PRODUCT SERVICE ADVISORY

**PowerFlex 700 AC Drives (20B), PowerFlex 700S (20D) AC Drives,
Frame 5, AC Input only and Spare Part Kit # SK-G9-XFMR1-F5**

Ref: CPAG 2006-10-003

Date: October, 2006

Frame 5 Fan Transformer Spare Part Kit # SK-G9-XFMR1-F5

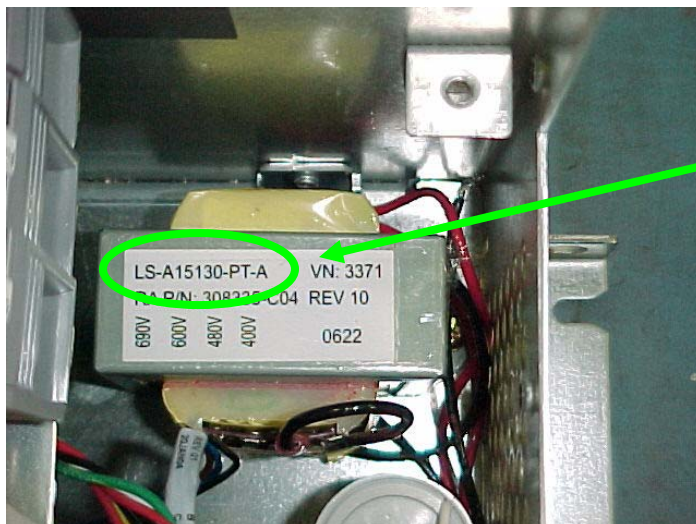
- PowerFlex 700/700S Frame 5 AC input drives have experienced fan transformer failures with transformer part #LS-A15130-PT-A. If the transformer fails, the fan will cease operation and the drive may experience heatsink over-temperature faults. When the transformer fails, an ionization occurs that may cause additional failures or damage within the drive.
- The issue can be avoided with an alternate fan transformer.

Note Transformer Part
Number
“LS-A15130-PT-A”

Any PowerFlex 700 or PowerFlex 700S Frame 5, AC Input drive with one of the catalog numbers noted above that has transformer part #LS-A15130-PT-A should have the transformer replaced. Kit # SP-337035-A01 includes the replacement component and instructions.

Figure 1

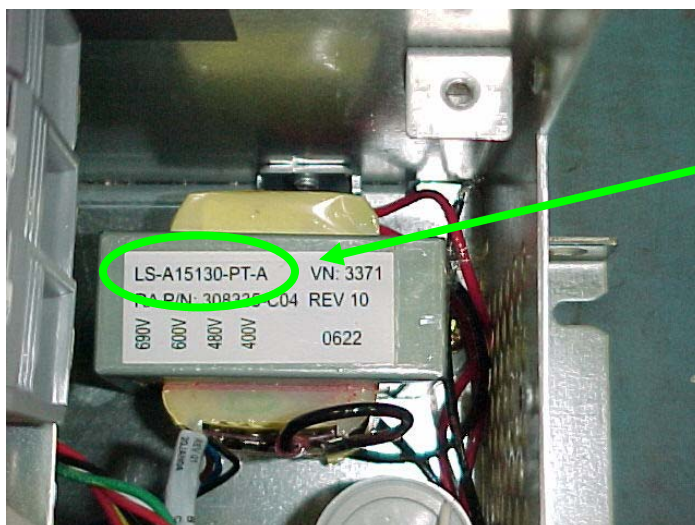
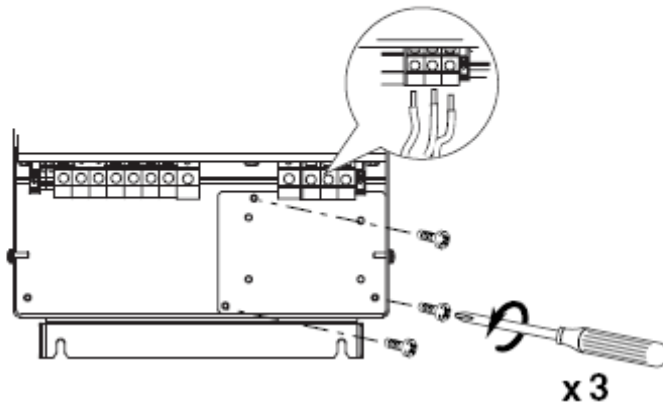
- Frame 5 Fan Transformer Spare Part Kit # SK-G9-XFMR1-F5
- Rockwell Automation shipped the affected products between September 15, 2005 and August 31, 2006.
- The suspect fan transformer can be identified by transformer part #LS-A15130-PT-A. The transformer is located at the bottom of the drive and can be accessed as shown below.

- A. Remove the R, S & T power wires from the terminal block. Remove screws from cover plate.**

Note Transformer Part Number
"LS-A15130-PT-A"
